OVC-HEV test sequence proposal JRC

Sustainable Transport Unit, Energy Transport & Climate
7th January 2020

Figure A8/1
Possible test sequences in the case of OVC-HEV testing

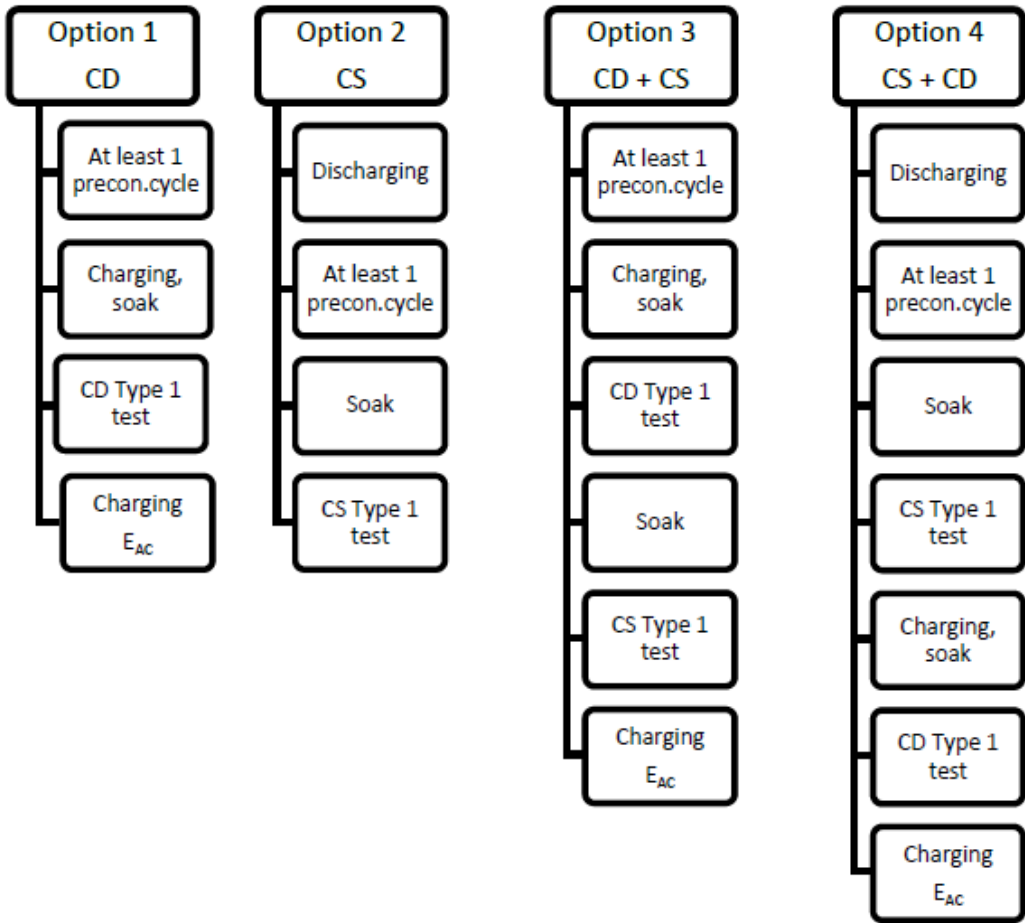
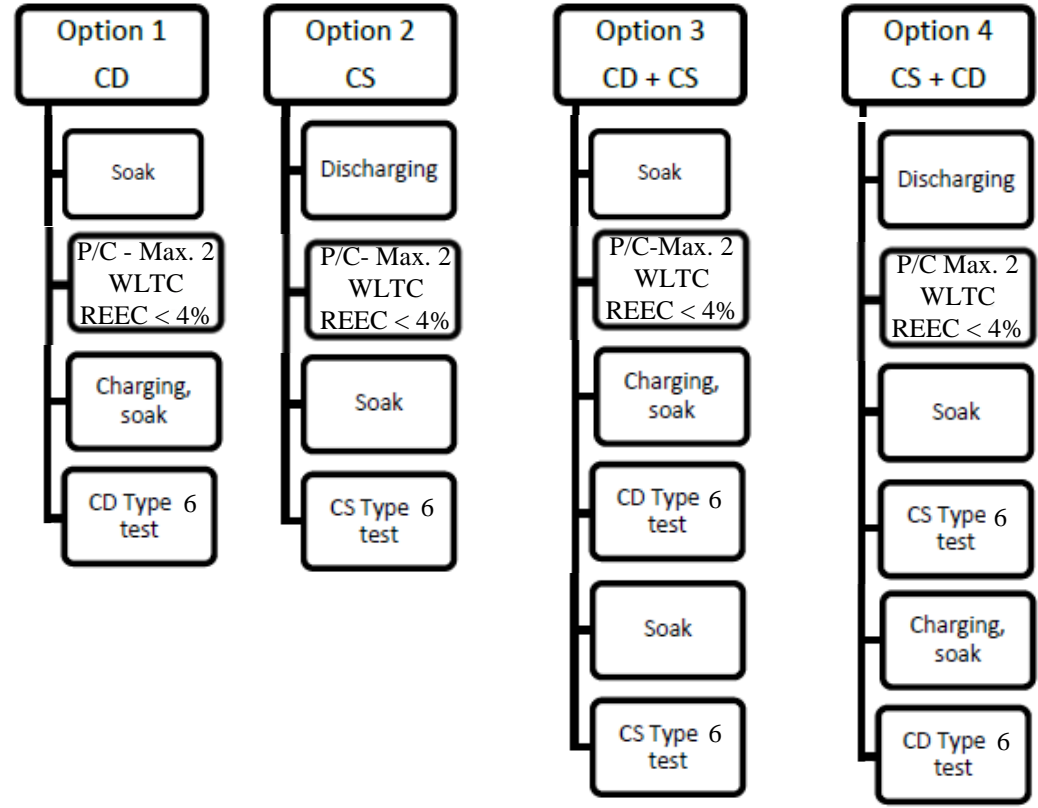
- CD & CS Type 6 test require auxiliary devices switched on
- During Soak and REESS charging, no pre-condition action should be initiated by user

- During Soak and RESS charging, no pre-condition action should be initiated by user.
- CD & CS Type 6 test require auxiliary devices switched on.
